Model	FAX 500/550, infotec 3301/3305, NRG 9620			Date of Modification	
Modified Article	PCB-Op-Port			Expected Date	
Reason for Modification	<input checked="" type="checkbox"/> Parts catalog correction <input type="checkbox"/> To meet standards () <input type="checkbox"/> To facilitate assembly <input type="checkbox"/> Vender change <input type="checkbox"/> Part standardization <input type="checkbox"/> To increase reliability <input type="checkbox"/> Other				
				Execution Date	
We have registered the PCB- Op-Port anew as a spare part.

MODIIFICATION BULLETIN NO. AFO-006

MODIFICATION BULLETIN NO. AFO-015

MODIFICATION BULLETIN NO. AFO-020ISSUED ON Sep. 18, 1992

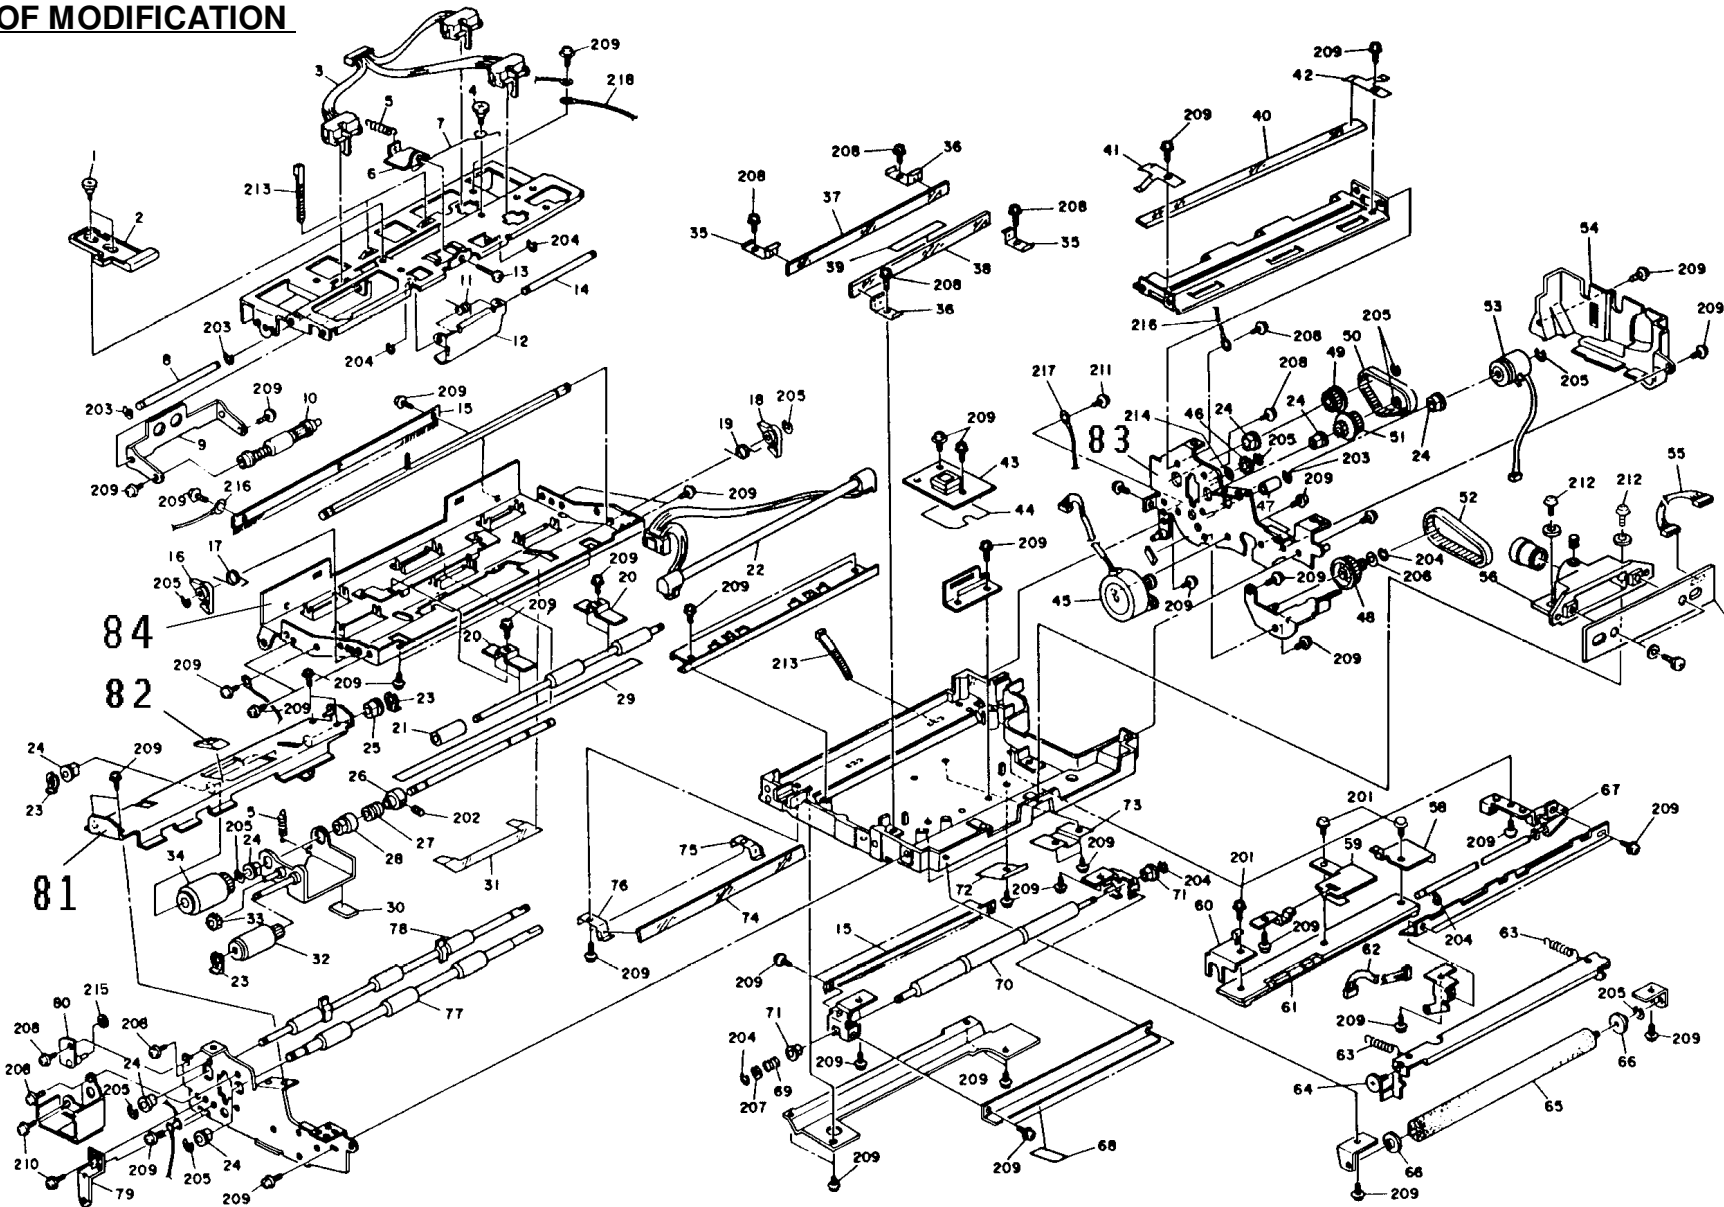
Model	FAX 500/550. infotec 3301/3305, NRG 9620	Date of Modification
Modified Article	Various	Expected Date
Reason for Modification	<input checked="" type="checkbox"/> Parts catalog correction <input type="checkbox"/> To meet standards () <input type="checkbox"/> To facilitate assembly <input type="checkbox"/> Vender change <input type="checkbox"/> Part standardization <input type="checkbox"/> To improve reliability <input type="checkbox"/> Other	
		Execution Date
Some parts have been registered as a service part.

Old Part No.	New Part No.	Description	Q'ty Used Old → New	Interchange- ability	Remarks	Parts Catalog	
						Index No.	Page
	H084 1503	Guide Plate - ADF: Lower	0 → 1		Same part as for model C	81	2 - 1
	H084 1520	Document Rail - ADF	0 → 1		Same part as for model C	82	2 - 1
	H084 1116	Side Plate Ass'y - Rear	0 → 1			83	2 - 1
	H084 1508	Guide Plate Ass'y - Upper	0 → 1			84	2 - 1

MODIFICATION BULLETIN NO. AFO-028

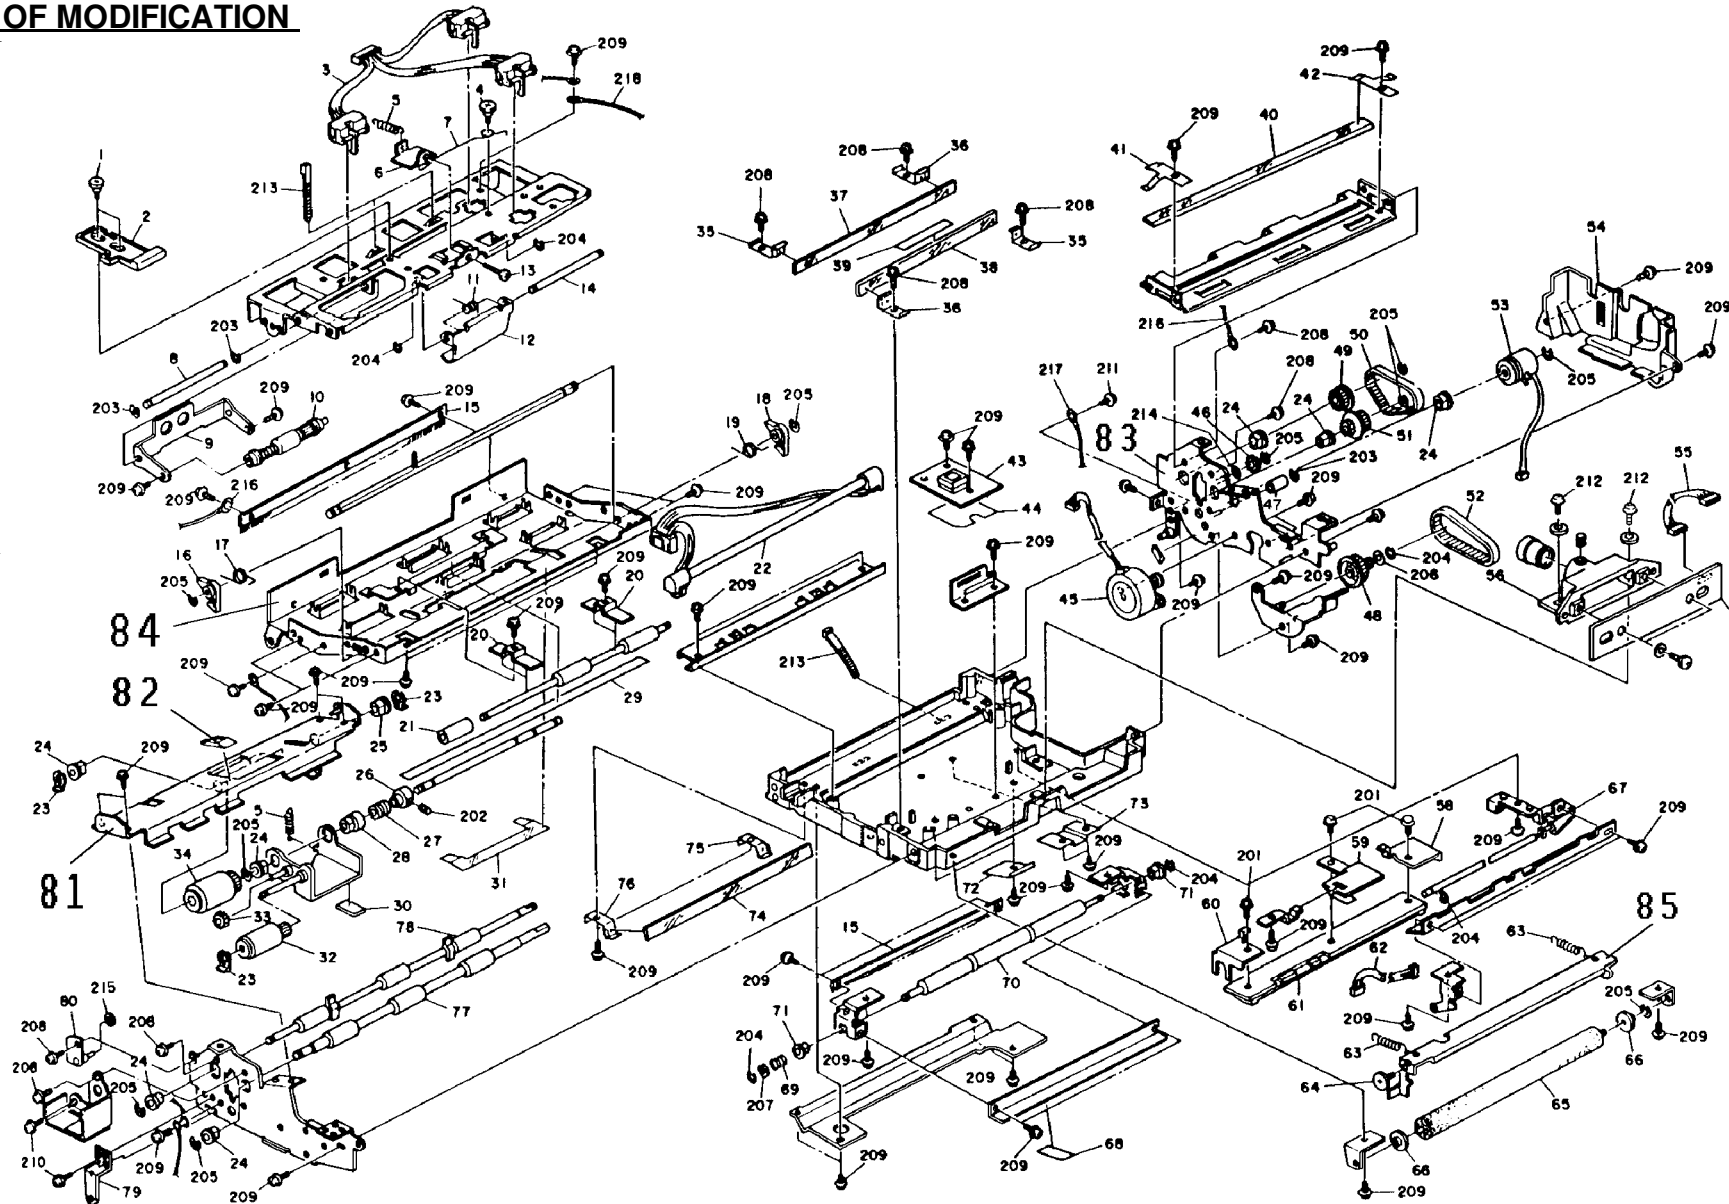
Model	FAX 500/550. infotec 3301/3305, NRG 9620	Date of Modification
Modified Article	Scanner	Expected Date
Reason for Modification	<input checked="" type="checkbox"/> Parts catalog correction <input type="checkbox"/> To meet standards () <input type="checkbox"/> To facilitate assembly <input type="checkbox"/> Vender change <input type="checkbox"/> Part standardization <input type="checkbox"/> To improve reliability <input type="checkbox"/> Other	
		Execution Date
The following part has been registered as a service part.

MODIFICATION BULLETIN NO. AFO-039ISSUED ON September 28, 1993

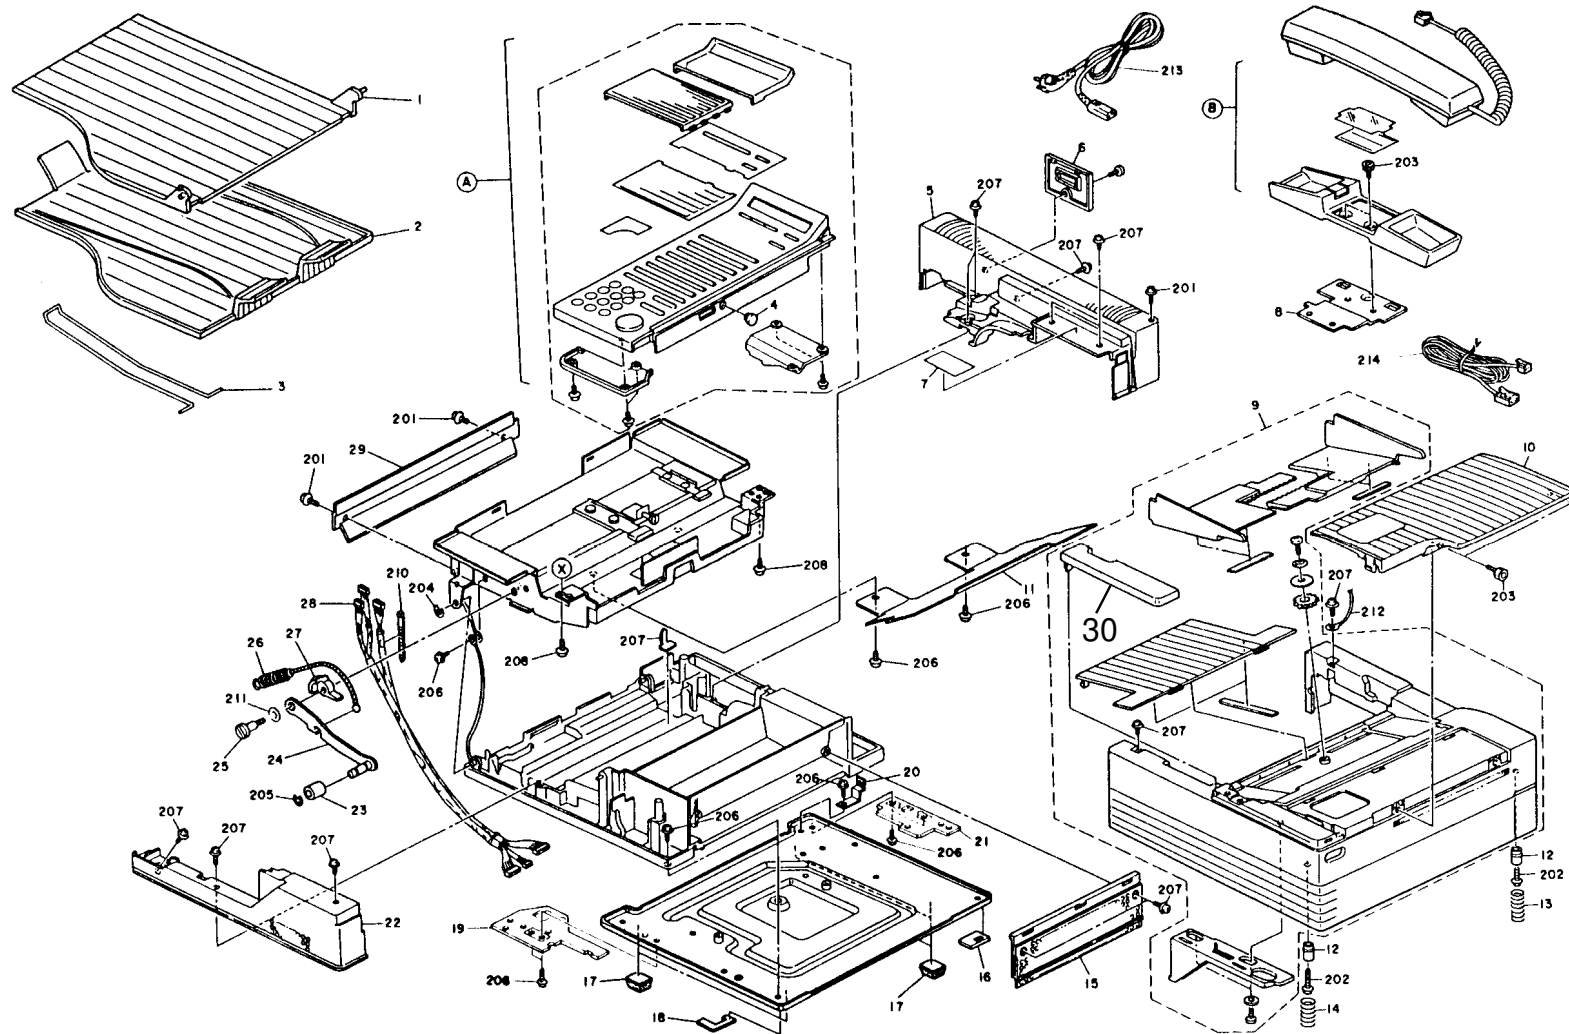
Model	FAX 500/550. infotec 3301/3305, NRG 9620					Date of Modification	
Modified Article	Cover					Execution Date	
Reason for Modification	<div style="display: flex; justify-content: space-between;"> <div> <input checked="" type="checkbox"/> Parts catalog correction <input type="checkbox"/> Vender change </div> <div> <input type="checkbox"/> To meet standards () <input type="checkbox"/> Part standardization </div> <div> <input type="checkbox"/> To facilitate assembly <input type="checkbox"/> To improve reliability <input type="checkbox"/> Other </div> </div> <p>The following part has been registered as a service part.</p>						
Old Part No.	New Part No.	Description	Q'ty Used Old → New	Interchange- ability	Remarks	Parts Catalog	
						Index No.	Page
	H0843810	Cover - Upper - Front : Ricoh	0 → 1			30	1-1
	H0843910	Cover - Upper - Front : infotec	0 → 1			30	1-1
	H0863810	Cover - Upper - Front : NRG	0 → 1			30	1-1
